## **REMARKS**

This Amendment is submitted in response to the Office Action dated March 4, 2004, having a shortened statutory period set to expire June 4, 2004. In the present Amendment, Claims 2 and 9-11 have been cancelled, and Claims 12-17 have been added. Claims 1, 3-8, and 12-17 are now pending.

FIG. 3

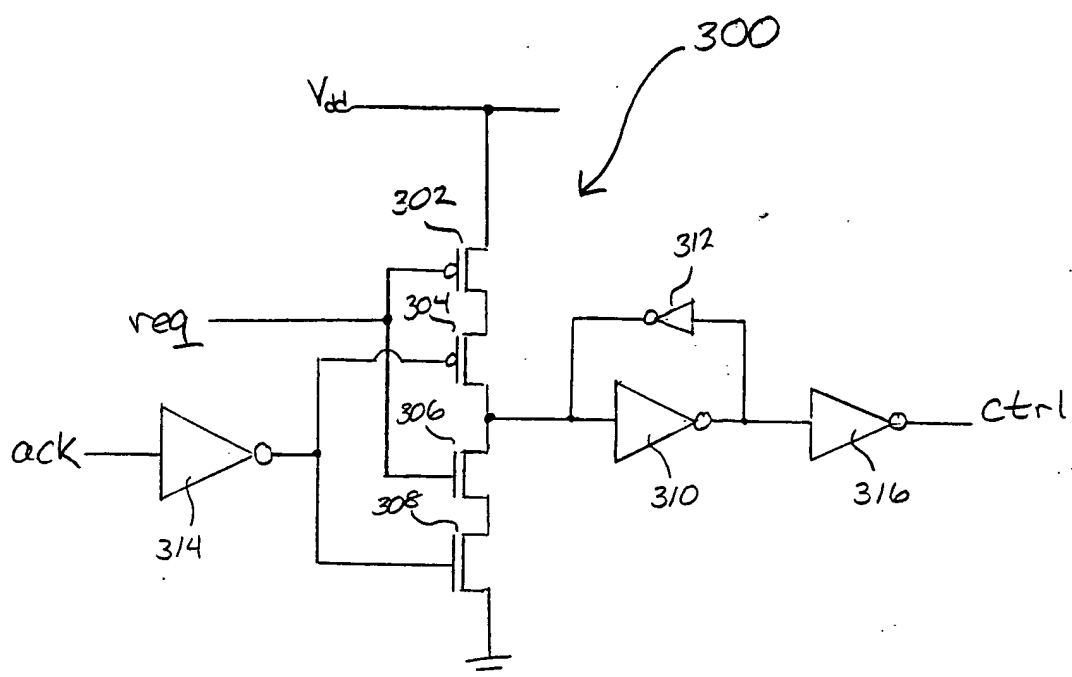
Responsive to the Examiner's correct observation, Figure 3 has been amended as indicated on the attached amended figure sheet to include the legend "Prior Art."

-- Prior Art --
